Sent on 06 14 2011 **Expires on** 07 14 2011
From Motorcycle Service Communications
Subject SAFETY RECALL: VT750C/C2B Bank Angle Sensor Replacement, REVISED Servi

Bulletin Number: 11-0236

SAFETY RECALL

2010-2011 VT750C/C2B Bank Angle Sensor Replacement

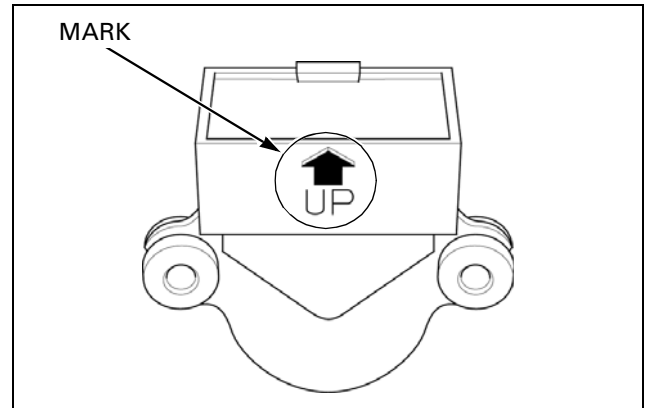
The revised Service Bulletin for this safety recall (campaign R80) is now posted on iN. The revisions to the bulletin are the inclusion of the customer letter on pages 5-6 and a revision of Step 8 of the repair procedure; identified by a NEW bar adjacent to the text and photo.

8. Remove the bolts, collars and bank angle sensor from the stay and bracket.
Install the updated bank angle sensor to the stay and bracket as shown.
Install the collars, bolts and tighten the bolts securely.

VT750C Only:

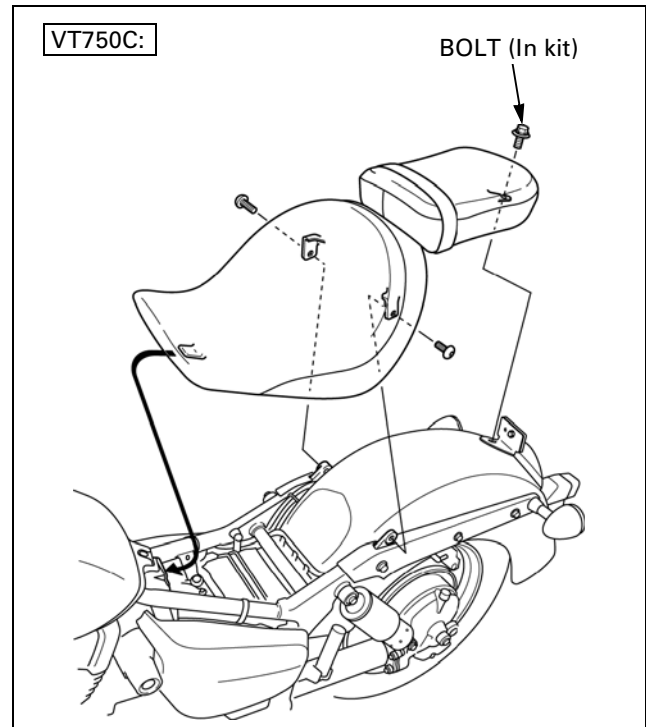
Install the seat using the new bolt supplied in the parts kit as shown.

NEW
